L-2014-063
10 CFR 2.202

St. Lucie Units 1 and 2
Docket Nos. 50-335 and 50-389

Florida Power & Light (FPL)/St. Lucie's Second Overall Integrated Plan Status Report in Response to March 12, 2012 Commission Order Modifying Licenses with Regard to Requirements for Mitigation Strategies for Beyond-Design-Basis External Events (Order Number EA-12-049)

Second Six Month Status Report for the Implementation of Order EA-12-049, Order Modifying Licenses with Regard to Requirements for Mitigation Strategies for Beyond-Design-Basis External Events

Figure 1 PSL FLEX Electrical Connections (Unit 1) (Rev 0A)

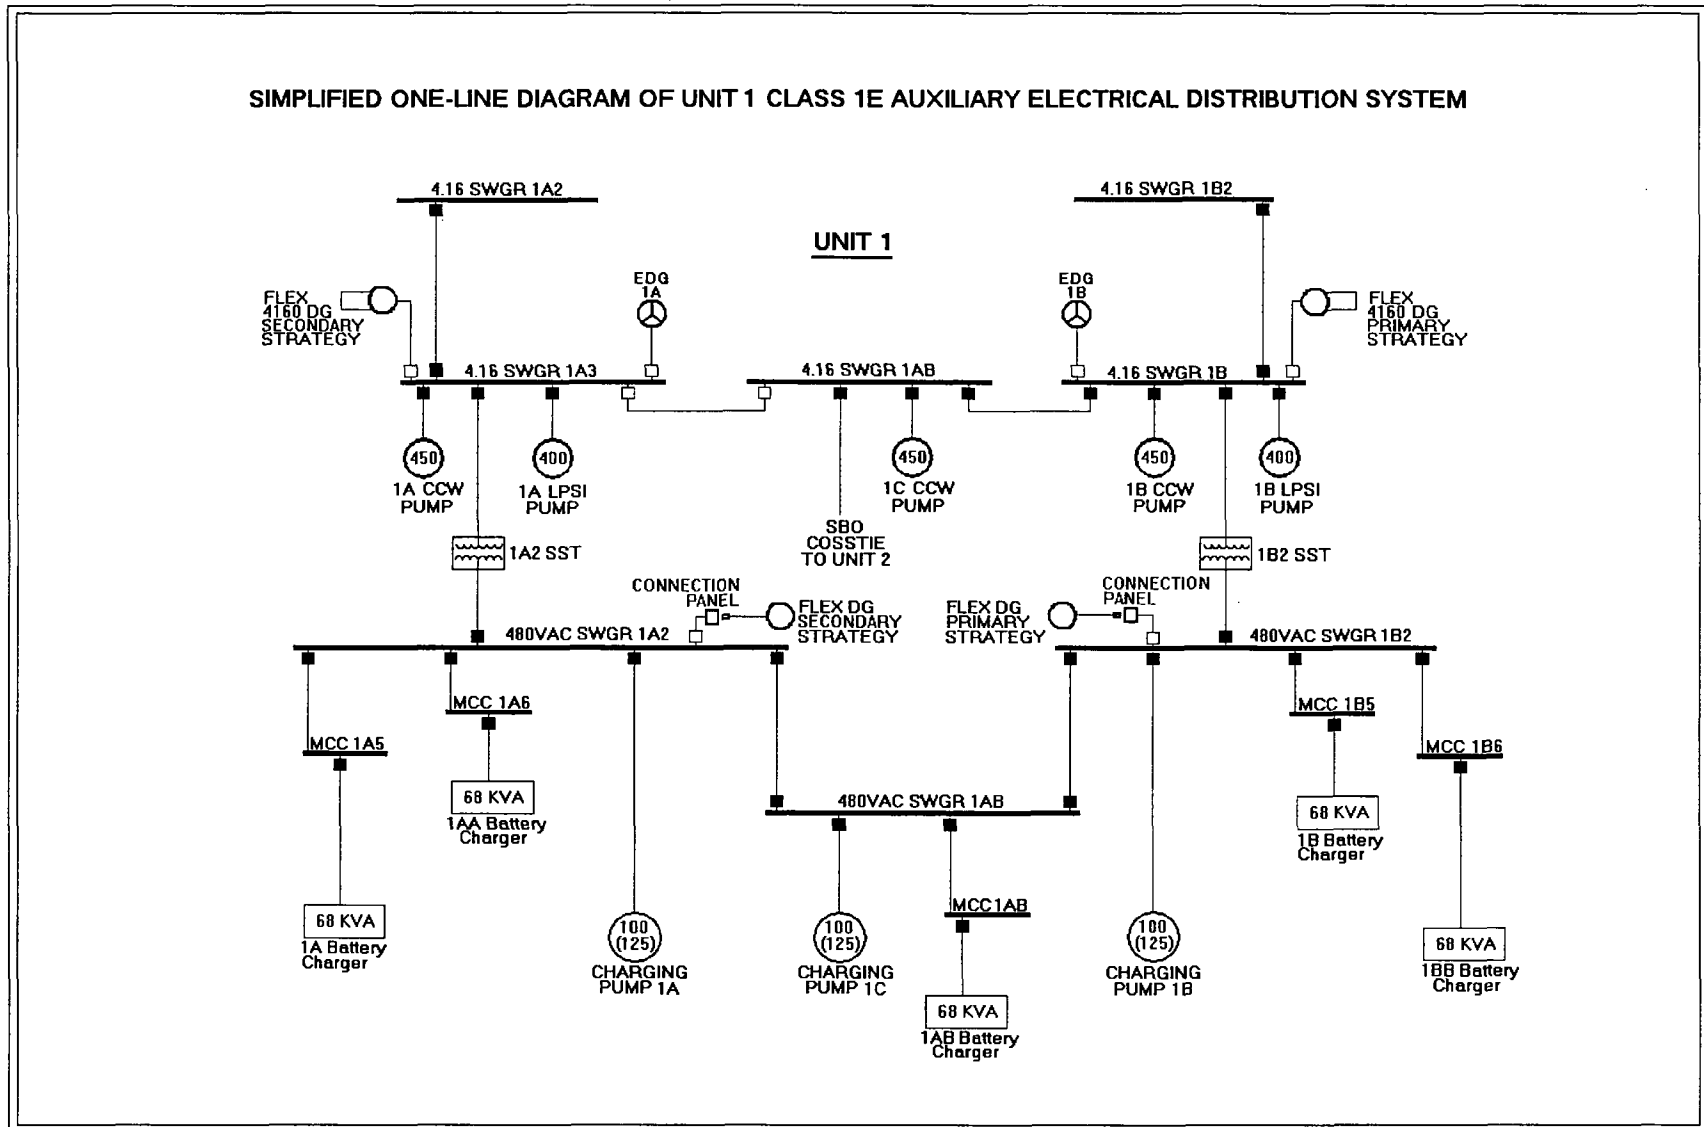
The St. Lucie FLEX strategy for making electrical system connections has evolved from that indicated in the Reference 1 response figures to be consistent with NEI 12-06 guidance (Reference 4). Refer to attached revised electrical connection figures; final versions will be provided in a future six-month update. Note the 480 volt connections will now be made using procedurally controlled breakers rather than using transfer switches.

Figure 13 Connections for SG FLEX Pump Discharge to AFW Pump Discharge Lines (Rev 0A)

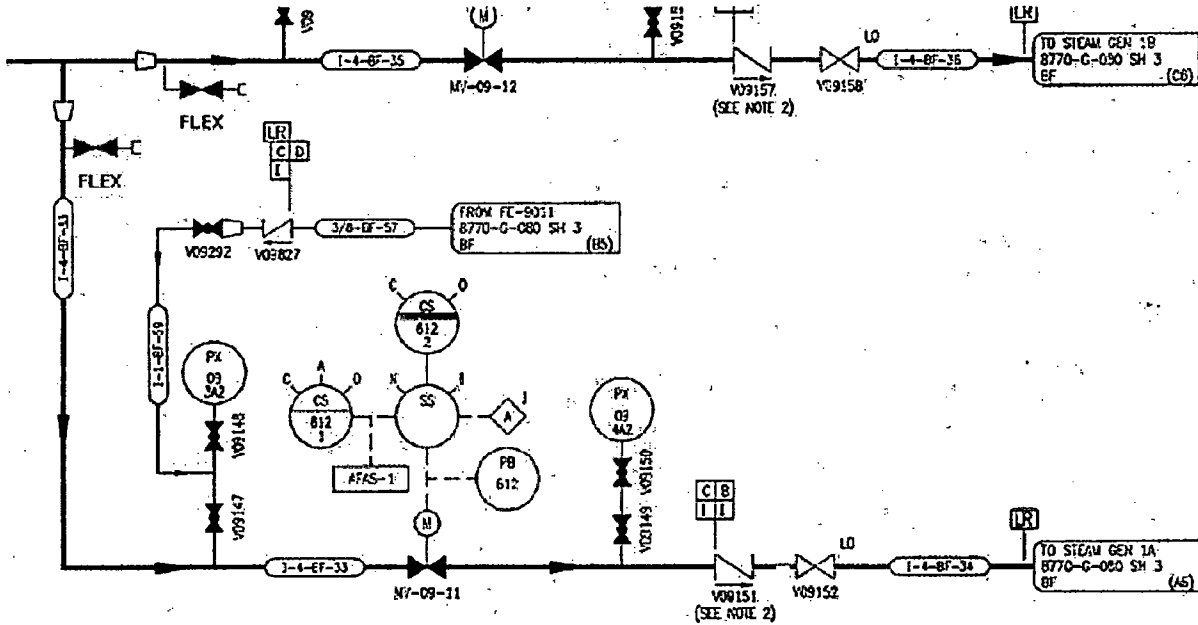
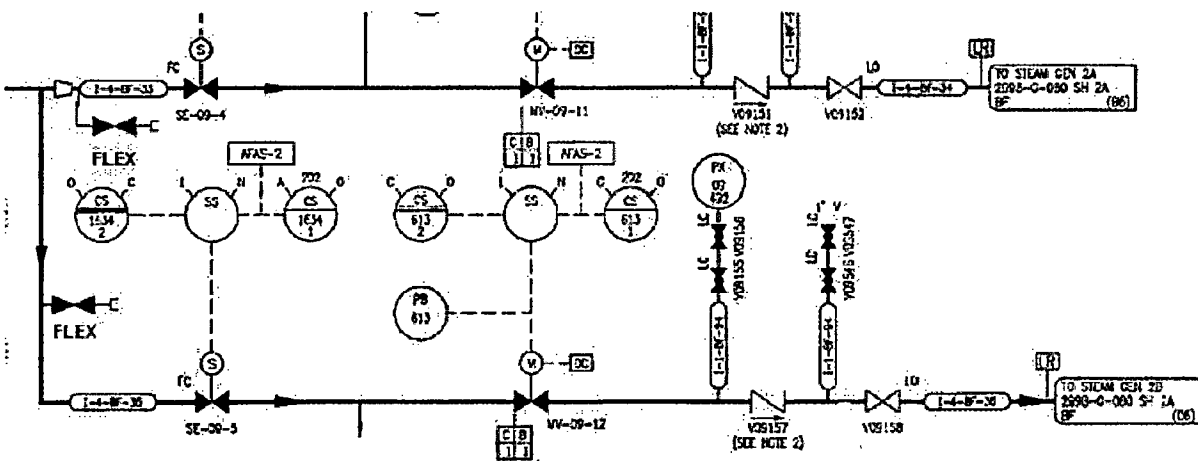
Install a 4" isolation valve and hose connection to the AFW pump 1C(2C) discharge piping for Steam Generator Injection by using a FLEX pump.

Figure 14 Connections for SG FLEX Pump Discharge to LPSI Pump Discharge Lines (Rev 0A)

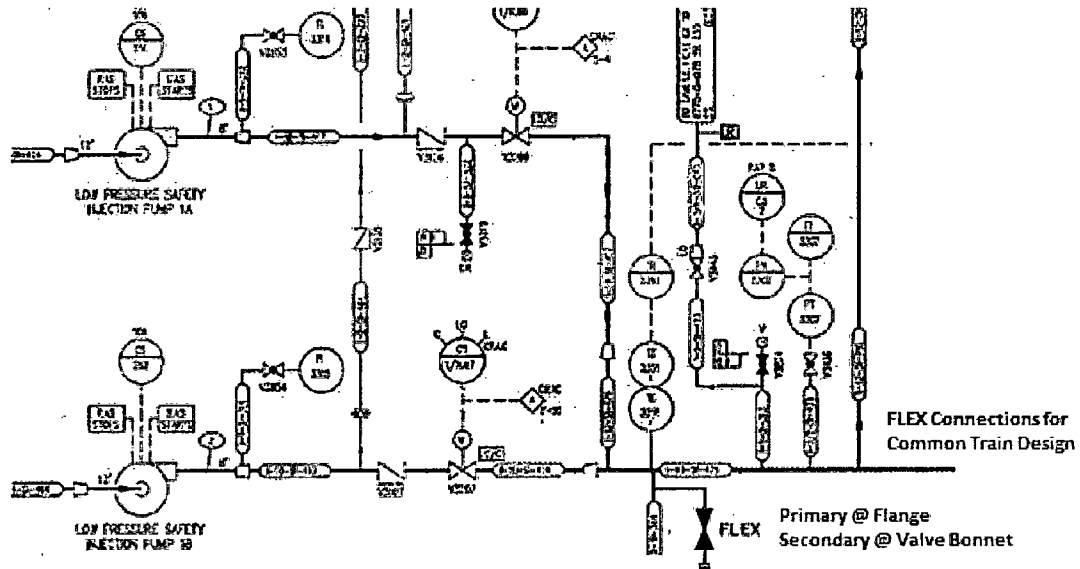
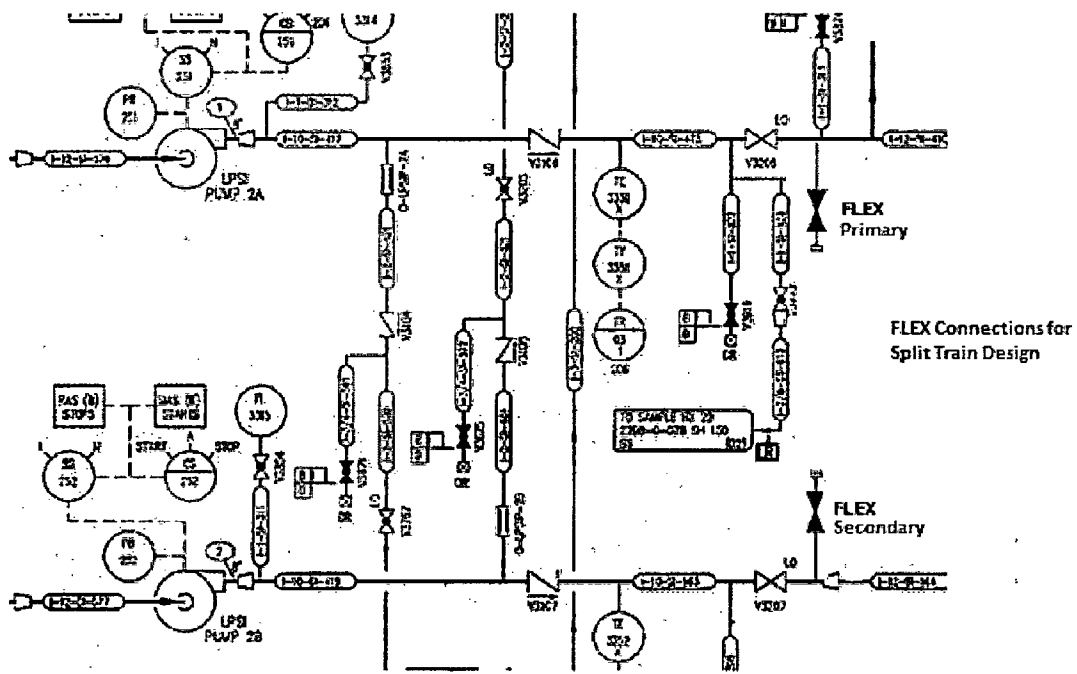
Install a 3" – 4" isolation valve and hose connection on the LPSI 1A/1B and LPSI 2A/2B discharge piping. For RCS cold leg injection with FLEX pump drawing suction from the RWT.

Figure 17 Connections for RRC LUHS Pumping System (Unit 1) (Rev 0A)

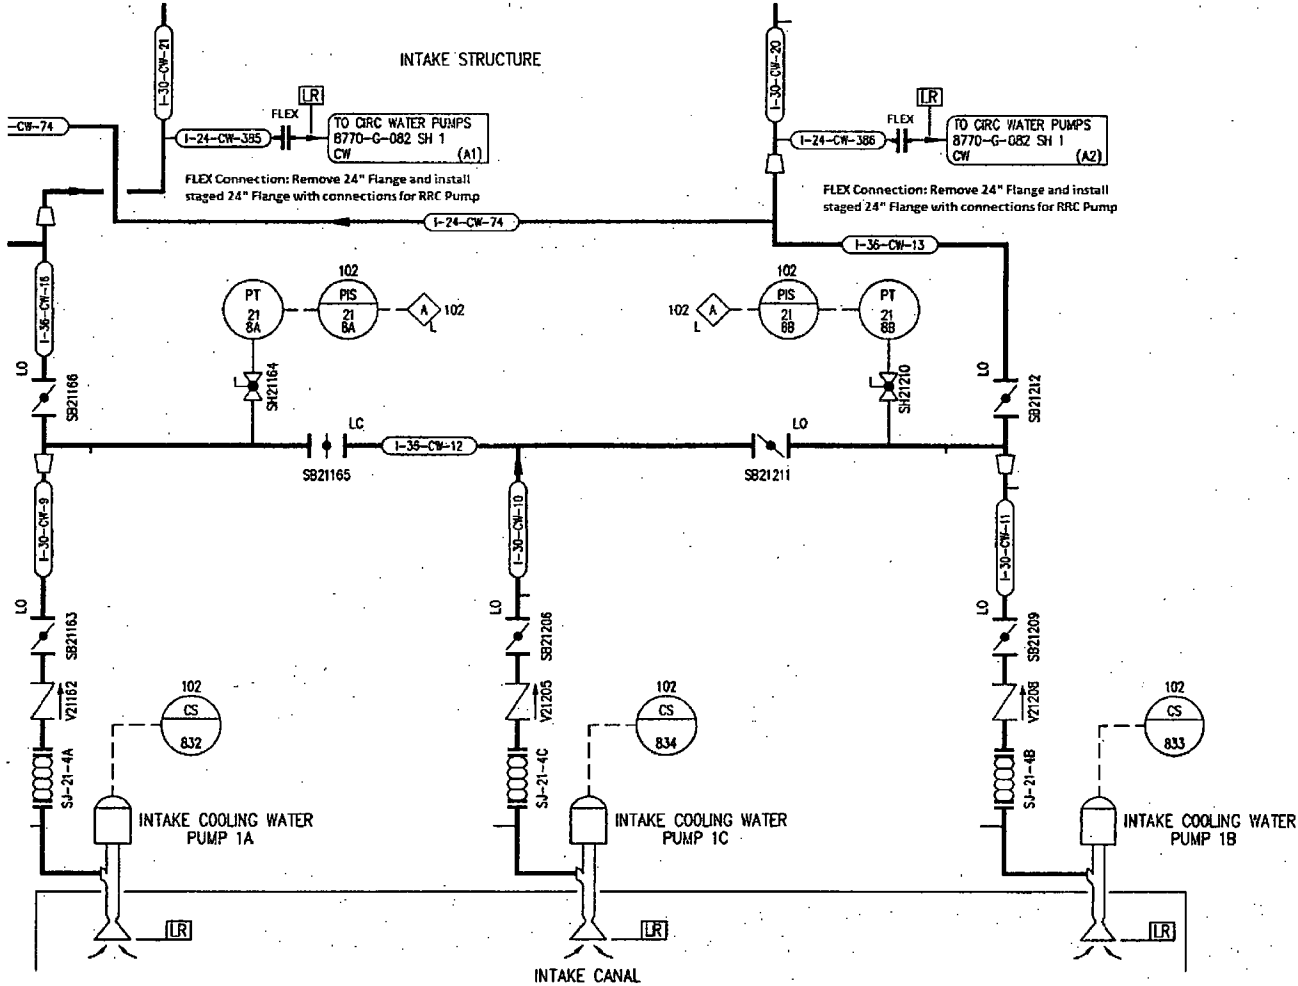
The Reference 1 FLEX response (page 68 of 102) indicated a pump would be provided from the Regional Response Center (RRC) to replace the function of the Intake Cooling Water Pumps due to the Loss of Ultimate Heat Sink (LUHS) event. The design point of the SAFER RRC pump is 5000 gpm at 150 psi. The LUHS Pump criteria mentioned in Reference 1 (page 72 of 102; 7162 gpm, 90 psi) is altered to align with SAFER provided equipment. The nominal flow rate of 5000 gpm is adequate for Shutdown Cooling in the timeframe for entry some 72-120 hours after shutdown. The RRC generic pump has inadequate suction lift for the intended deployment of the RRC pump on the intake structure deck. An RRC supplied diesel/hydraulic driven suction booster pump will be used to provide the required lift capability. This pump combination will allow water to be

drawn from the intake structure downstream of the traveling water screens (non-seismic) to address debris concerns in a hurricane scenario. A backup plan will locate the floating booster pumps within the intake canal.
